ADDENDUM NO: 01

PROJECT: Center Grove MS Central Renovation

PROJECT NO: 2024017 DATE: June 25, 2025 BY: Jack Leibham

DRAWING NUMBER A802D PROJECT NUMBER

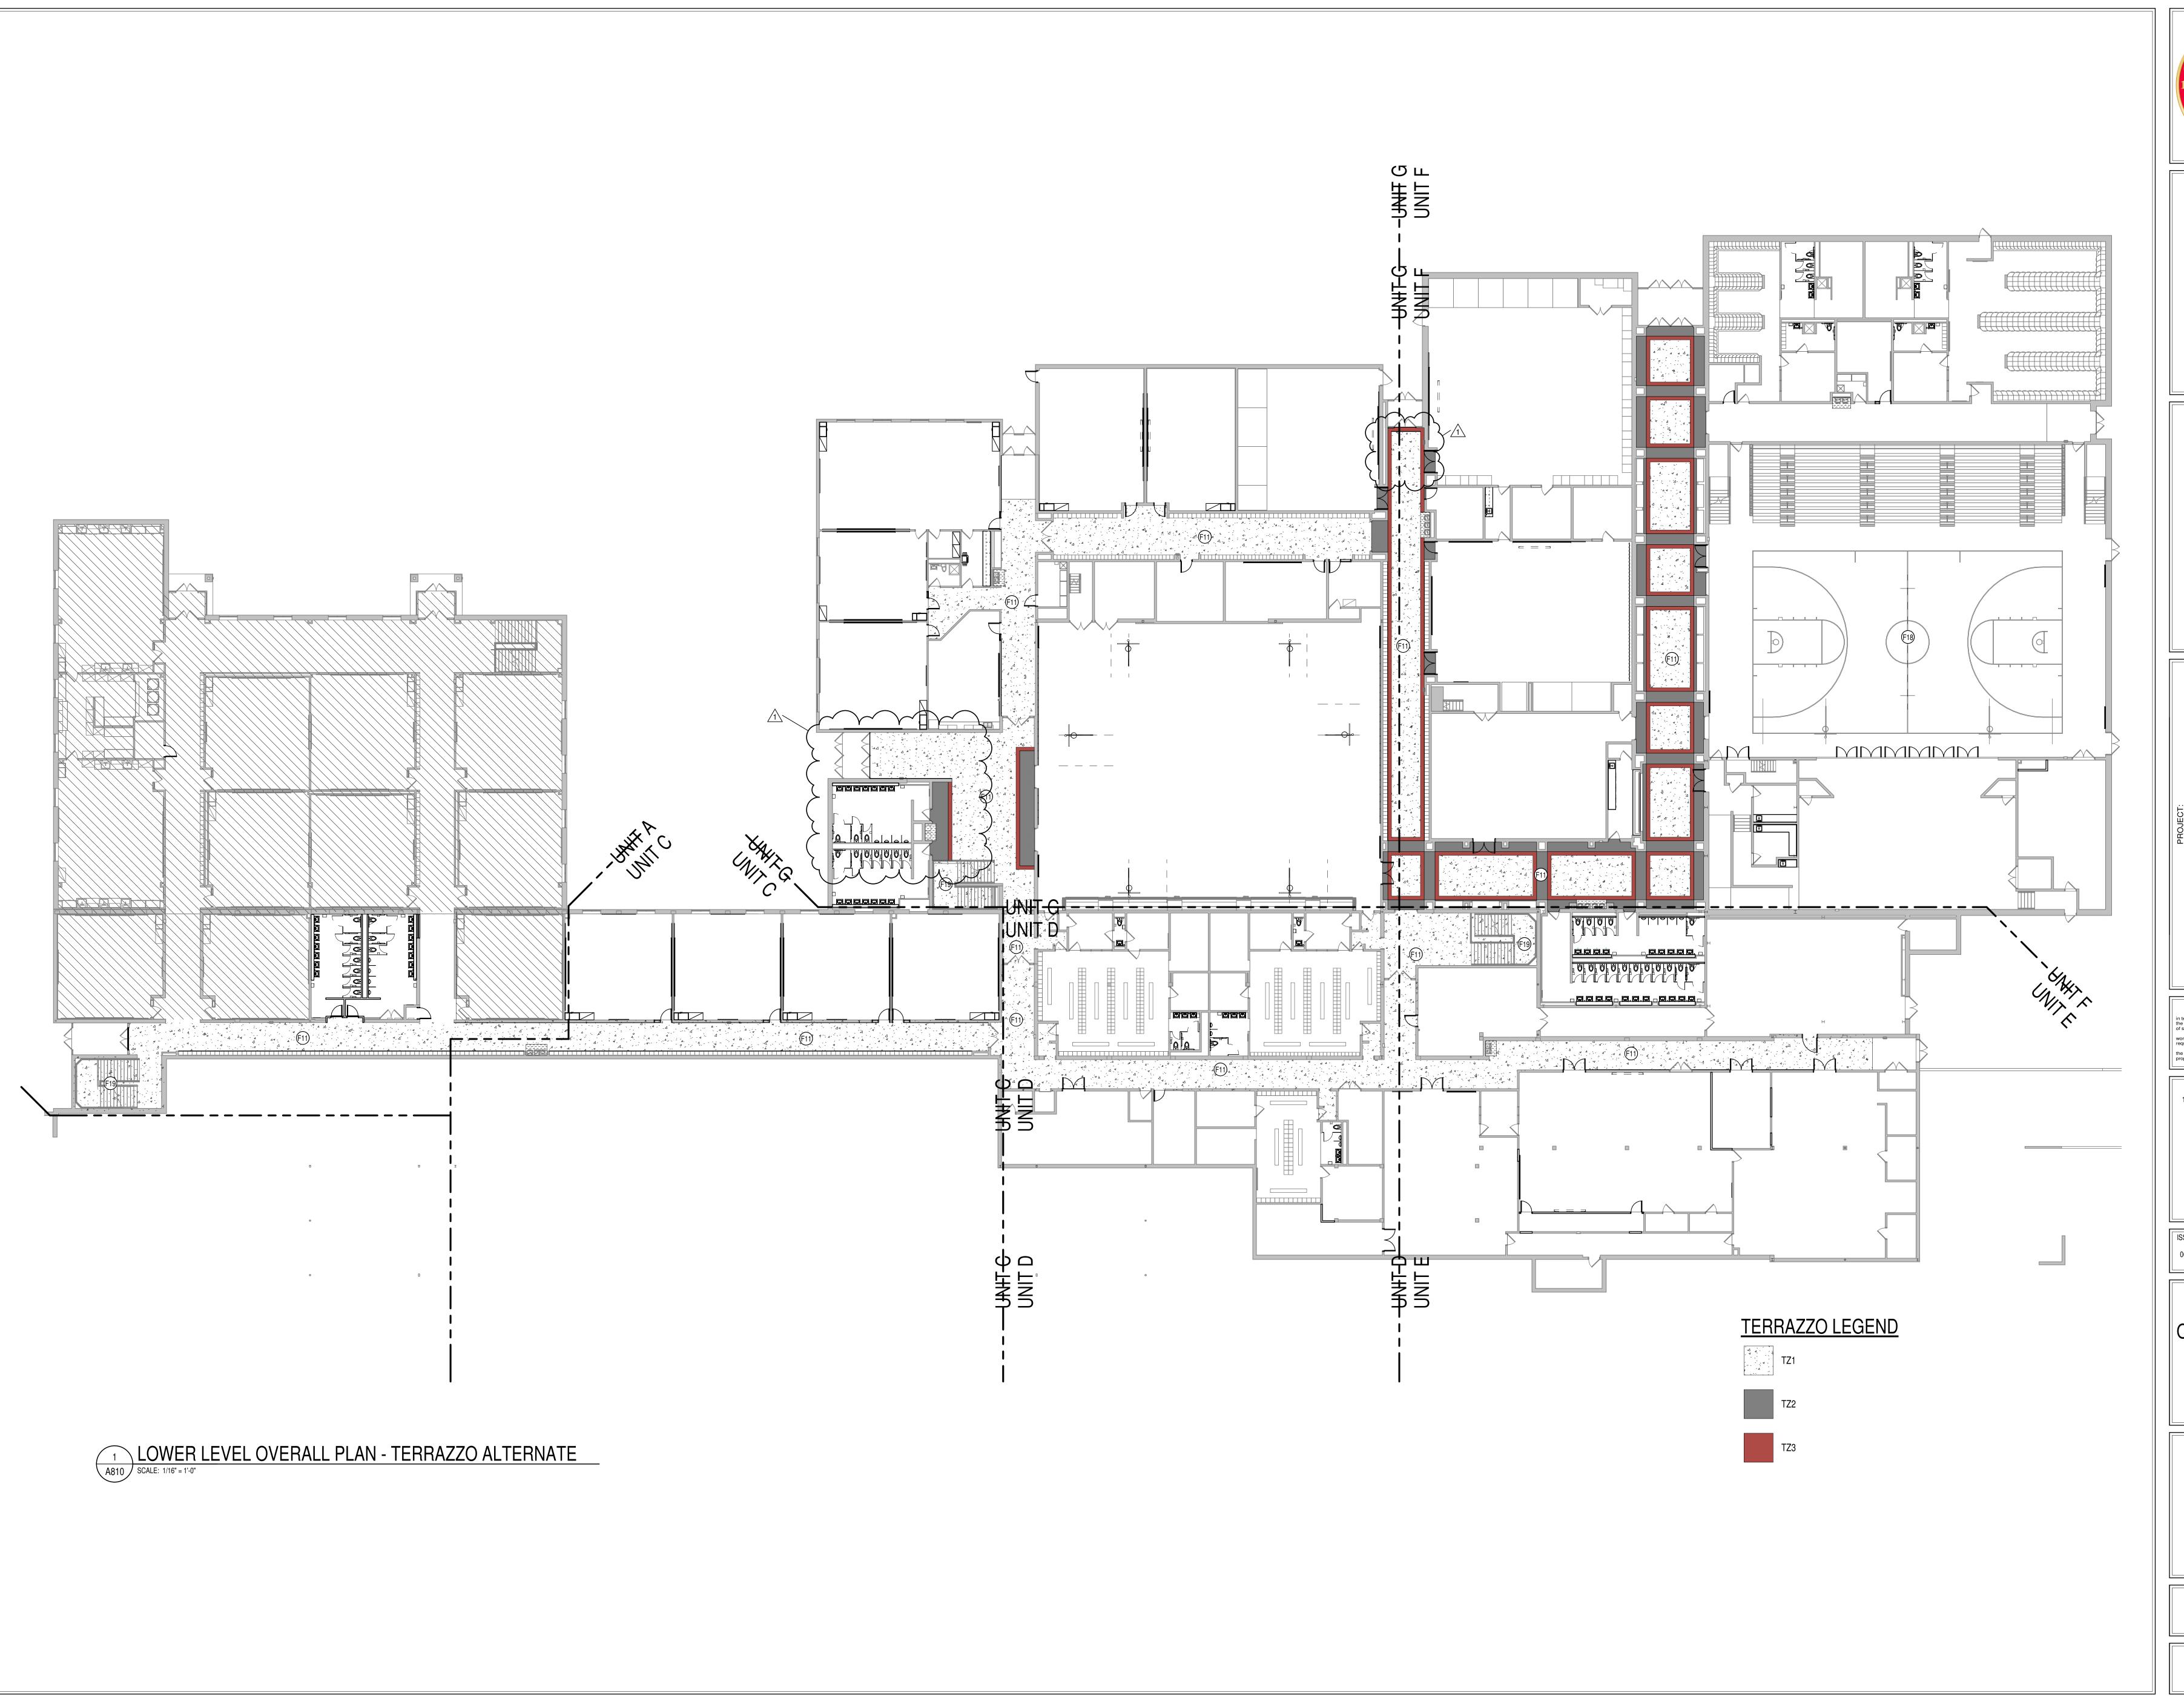
A. Revise WOC to **ETR** in Vestibule 001.
